Re: Proposed Private Hospital, Water Street Wahroonga

We refer to the various responses to the Part 3A Application relating to the subject proposal and advise that we have reviewed the matters raised and now confirm as follows in respect of the issues arising that pertain to traffic planning matters. These are considered separately below in response to the matters raised by the RTA, the matters raised by Council, and the matters raised in public submissions.

attachment 2

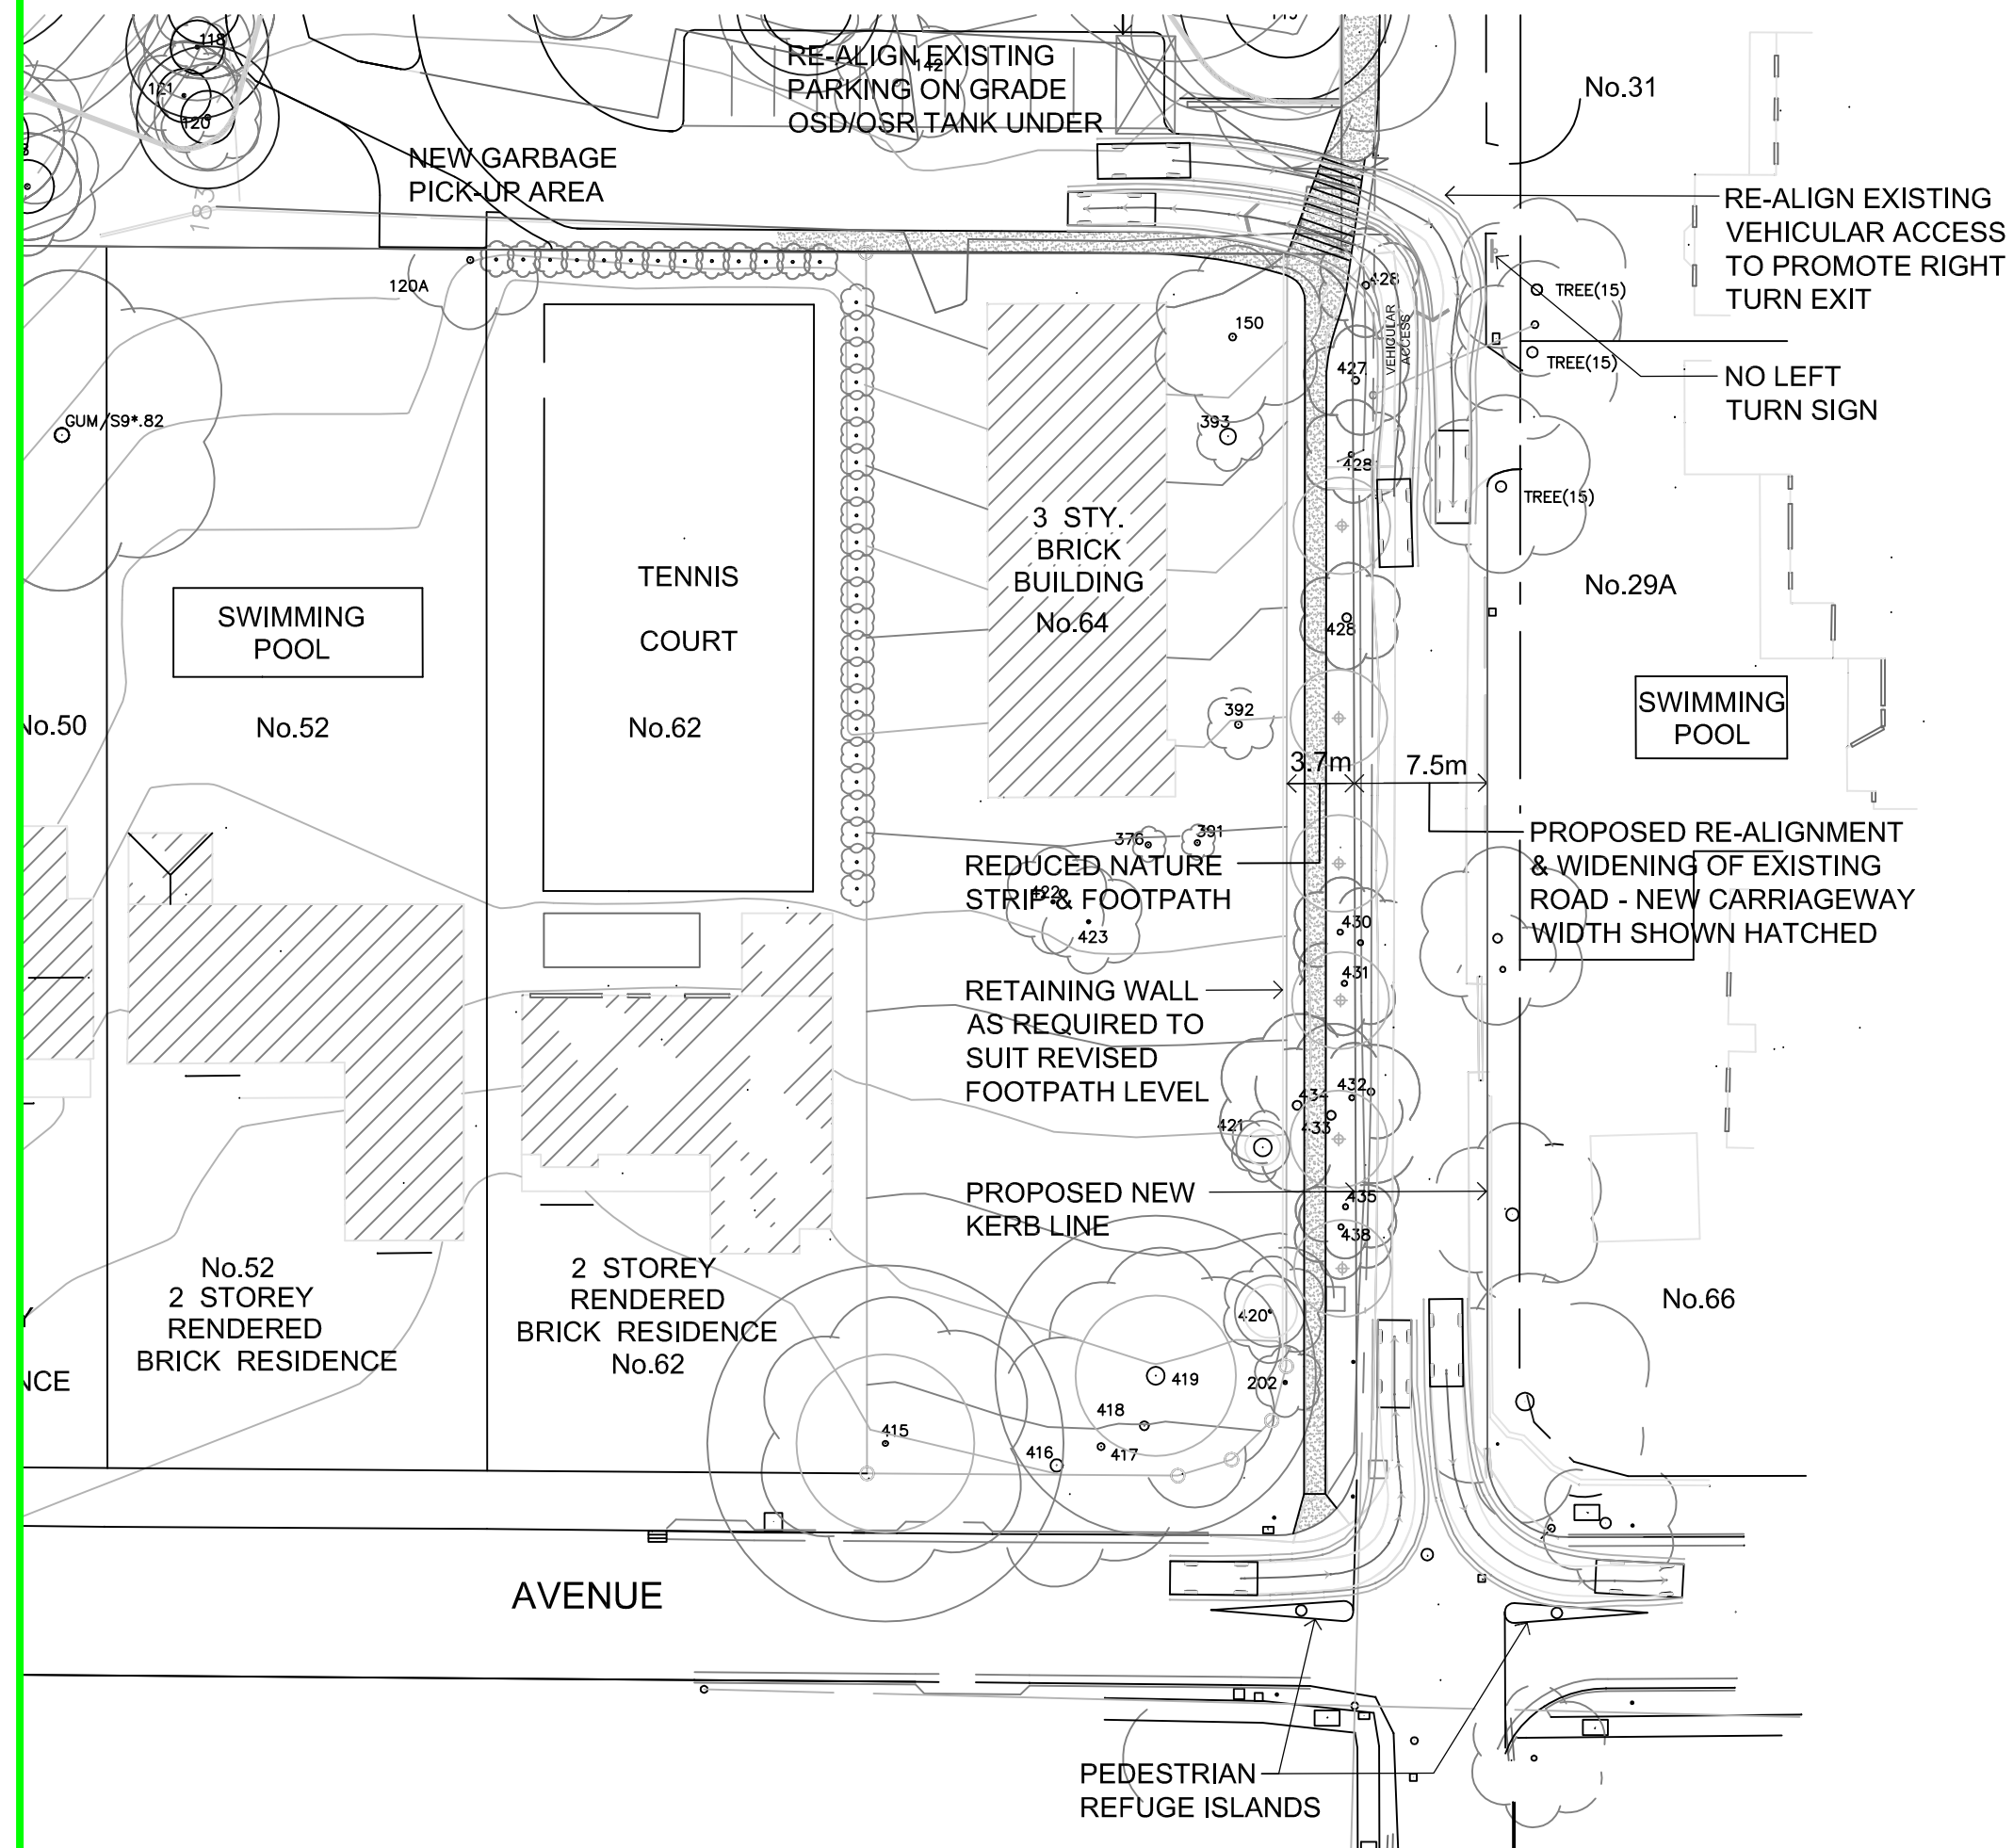
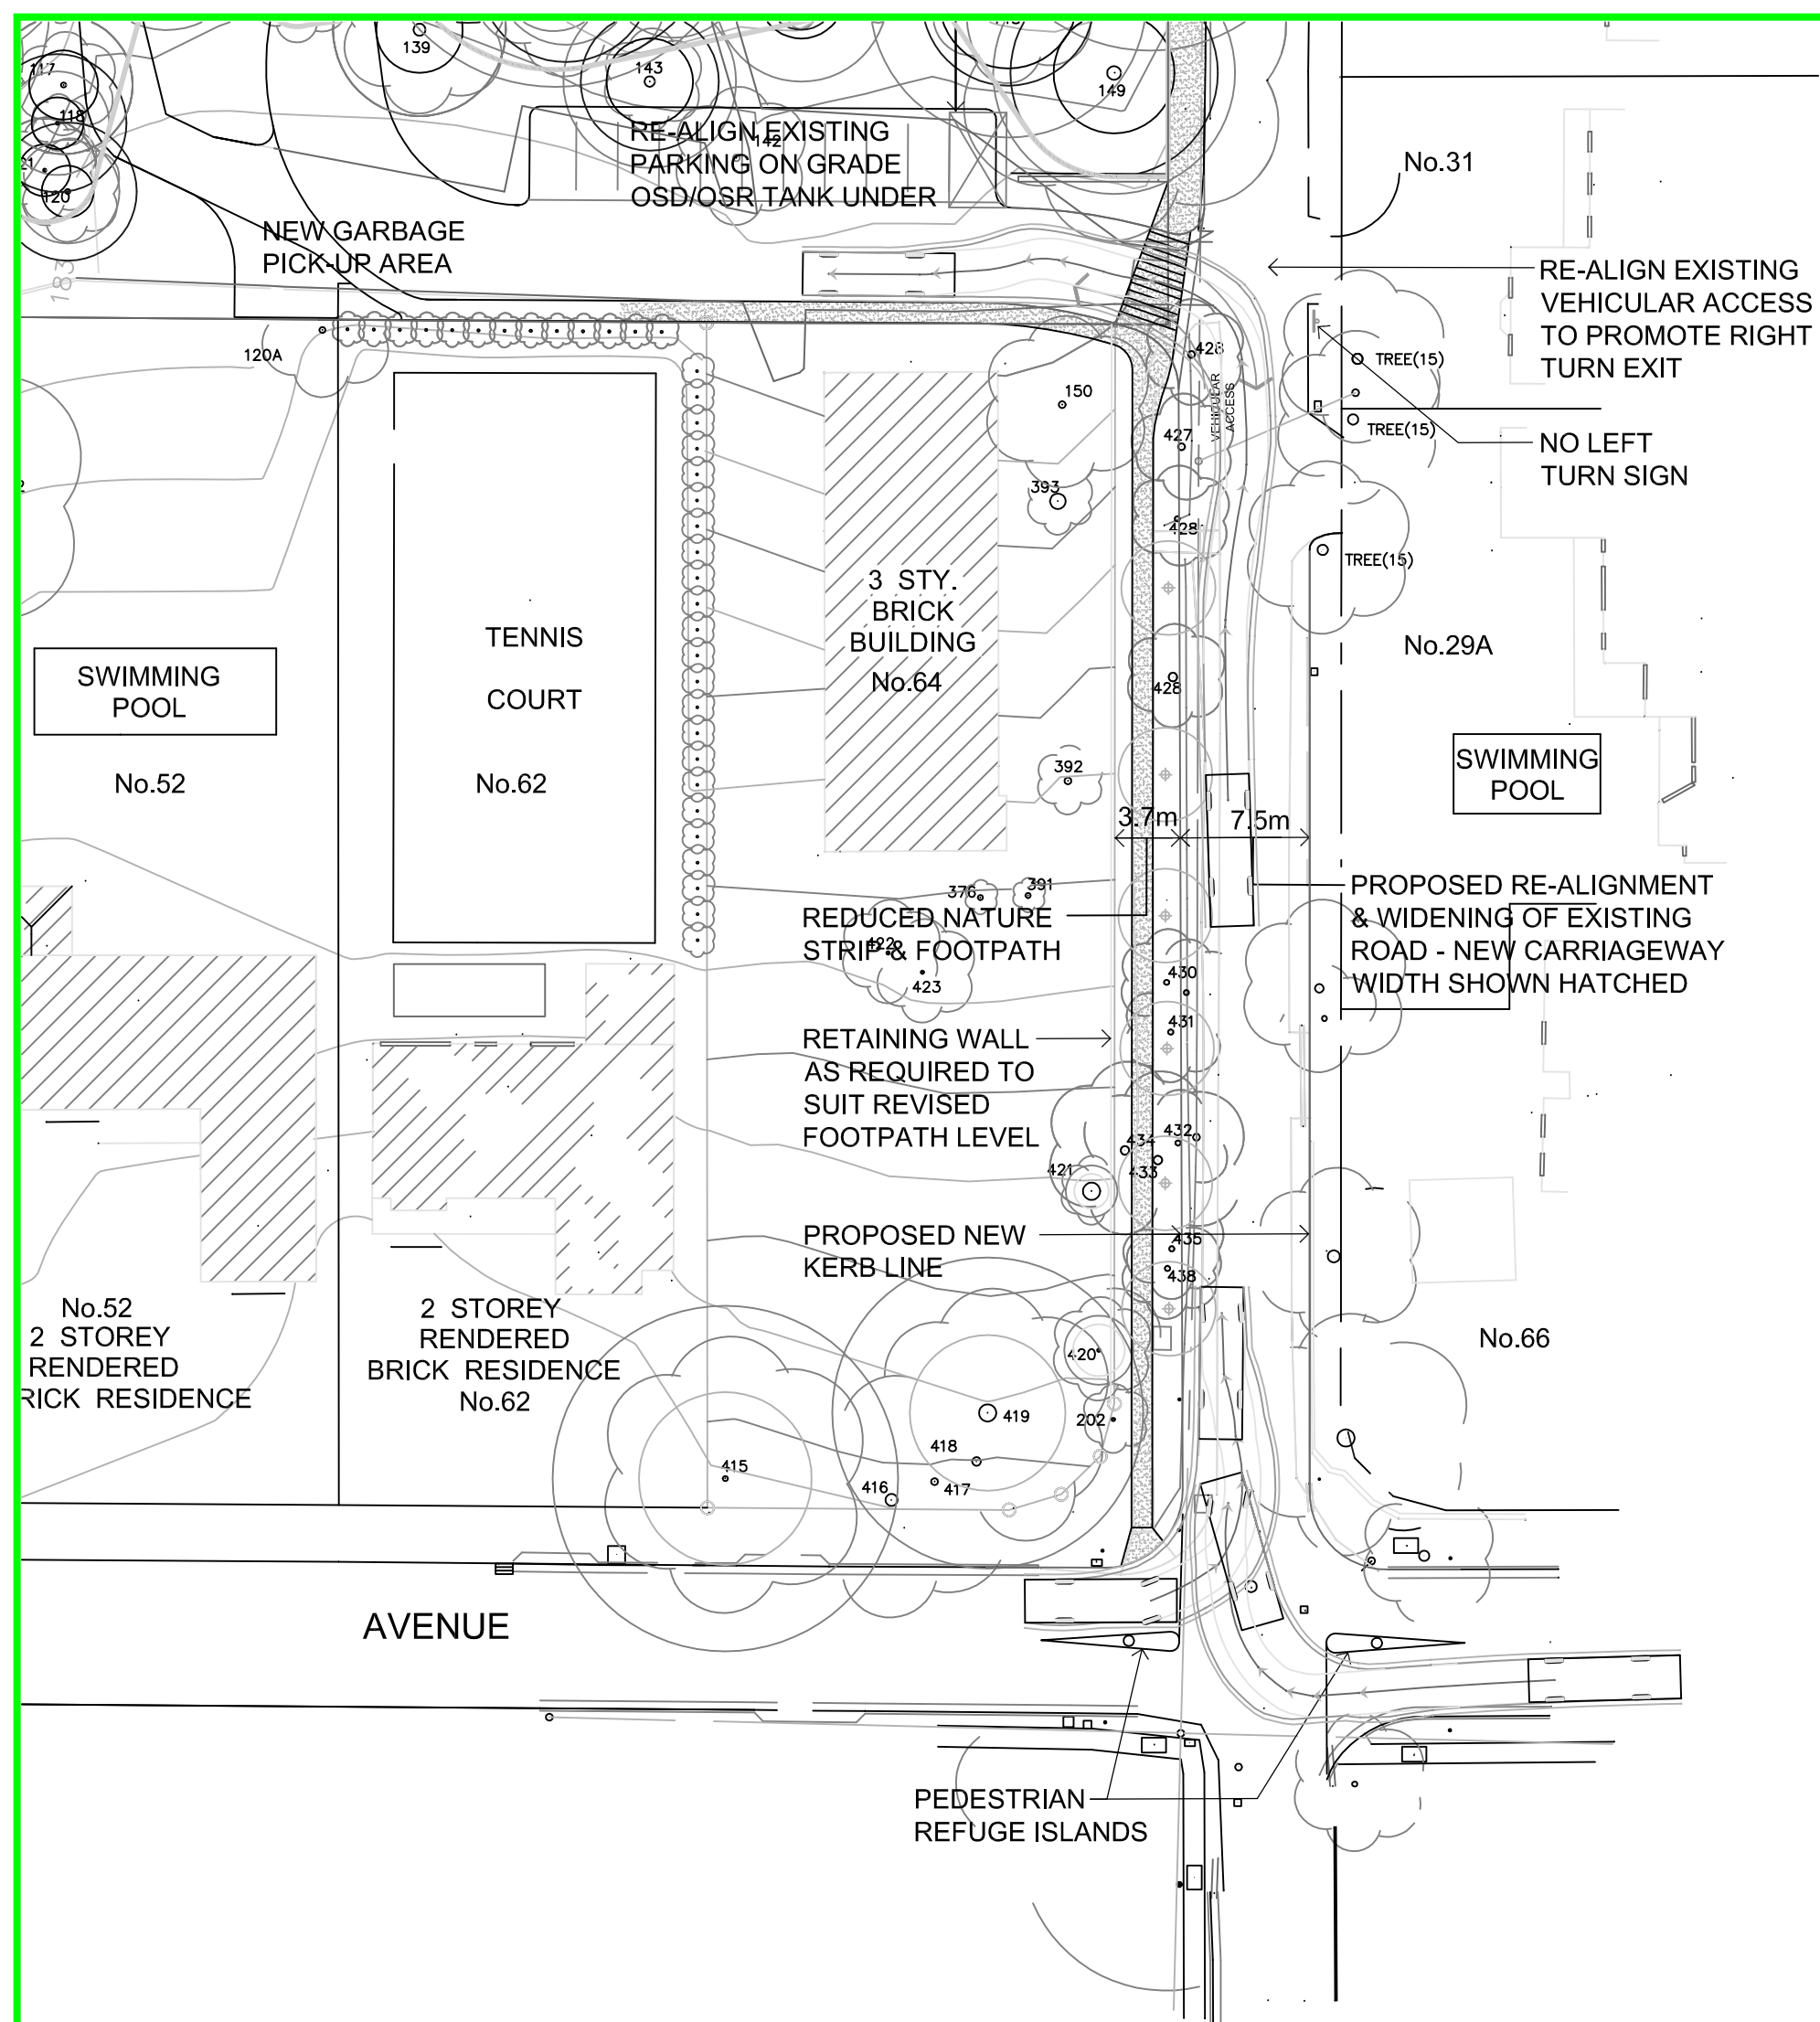
- The final design of the Young Street access can be dealt with on the basis of compliance with AS 2890.1. Nevertheless, concepts have been prepared which will result in a substantially improved outcome, with Young Street widened between the site access and Billyard Avenue. Two basic options have been prepared, comprising a 7.5m wide carriageway and a 9.0m carriageway (with a 3.7m wide road verge along the site frontage incorporating a footpath). Both are available for implementation and both are more generous than is required under AMCORD Guidelines, which we note is endorsed in the RTA's Guidelines. The 7.5m wide carriageway enables vehicles to pass without difficulty and also permits occasional/intermittent on-street parking to occur, associated with residents and their visitors. The ability of a car and an MRV (the standard service vehicle) to access the site via Young Street is shown in **Attachment 2**. It is noted that the driveway is slightly angled to encourage left turn entries to and right turn exits from the site. It is also proposed that a "No Left Turn" sign be placed opposite the driveway to effectively eliminate left turn exits movements onto Young Street.

- The swept paths provided in Attachments 2 and 3 demonstrate compliance using a Category 2 Driveway and no further widening is considered necessary. This width is also sufficient to accommodate occasional service vehicles. These swept paths demonstrate that the concept plans prepared for the road widening are supportable and able to be delivered. The final road designs will however presumably be the subject of a suitable condition of consent requiring that the road be constructed to Council's requirements, while the driveway will be subject to compliance with AS 2890. For reference and to assist comparison, the existing road geometry is provided in **Attachment 4**.
